NEW YORK STATE DEPARTMENT OF ENVIRONMENTAL CONSERVATION

Re: Lower Wee-Wah Lake Dam DEC Dam ID#: 196-0361, Class C – High Hazard Village of Tuxedo Park, Orange County Condition Rating: No Deficiencies Noted

Visual Observations

Photo 1 Dam ID# 196-0361 Lower Wee-wah Lake Dam 10/14/2021 Left upstream slope View looking right from left end of dam

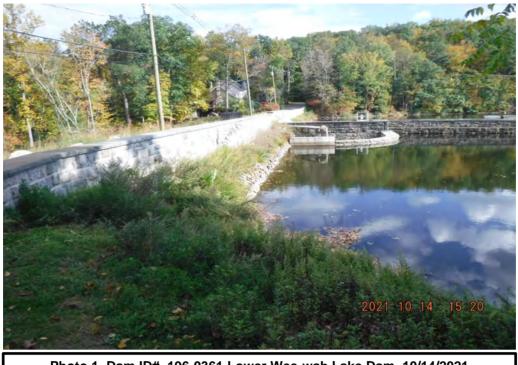
2)Slope Sta	1)Seepage2)Slope Stability3)Undesirable Growth			4)Maintenance7)Cracking5)Surficial Deterioration8)Movement6)Voids9)Data			g ent/Misalignment			
General: –Accompa	-Accompanied by Natalie Browne and Doug Upright from Region 3 Water during the inspection									
Upstream: —Tall grass and weeds growing from between the stones on both the left and right upstream slopes										
Dam Crest:										
–Dam crest is access road. Road and upstream parapet wall appear OK Downstream:										
 Both left and right downstream slopes are overgrown with tall grass and weeds. Grass obscured slopes so that a visual inspection could not be completed V-notch weir box for right side downstream toe drain reading was approx. 2-inches (gauge hard to read from staining). 										
Service Spillway: –Boards in place. No noted deficiencies										
Auxiliary Spillway: -Several locations of seepage through the base of the spillway face and on the spillway floor with orange staining.

The inspection revealed that the dam is generally in good condition however it was noted during our inspection that grass and weeds are growing from between the stones along the upstream slope and also the downstream slopes are becoming overgrown with taller grass and weeds. The Village should stay on top of maintaining/mowing the downstream slopes to not allow taller woody vegetation to re-establish on the slope. It was also observed during the inspection that the toe drain v-notch weir box is beginning to fill with sediment. This should be cleaned out periodically as part of the routine maintenance on the dam. Build up behind the v-notch will not give you an accurate representation of the flow from the drains.
